**Urbana, Safe Routes to School, Phase 2
ODOT PID #96388
Addendum #1**

Re: Addendum #1

REVISIONS:	DATE
12-20-12	APPROVED:
	01-13-06
	PAGE No.
	1167.10

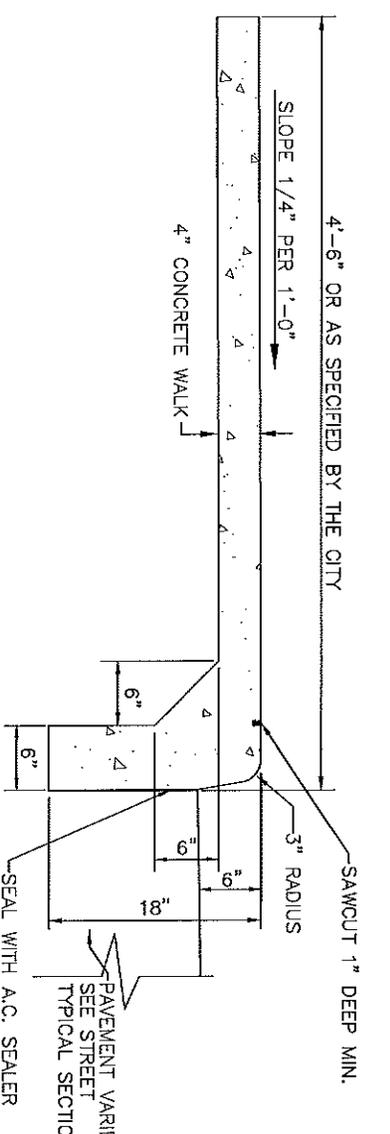
Q1: Can you send me your sidewalk detail?

Q2: Detail does not show any aggregate base. Is that correct?

R1: Please see City Standard 1167.10 (Concrete Sidewalk Detail) included with this addendum.

R2: The standard drawing shows sidewalk able to be poured on undisturbed earth. I interpret undisturbed earth as non-embankment material that is still compacted. Obviously you'll be scraping the sod and topsoil off, but the underlying subgrade should be OK to pour on. On Boyce Street though, you may need some compactable granular bedding because, according to the detail on page 2 of the plans, some embankment is needed under the street-side edge. All aggregate needed would be considered incidental to the sidewalk construction and price.
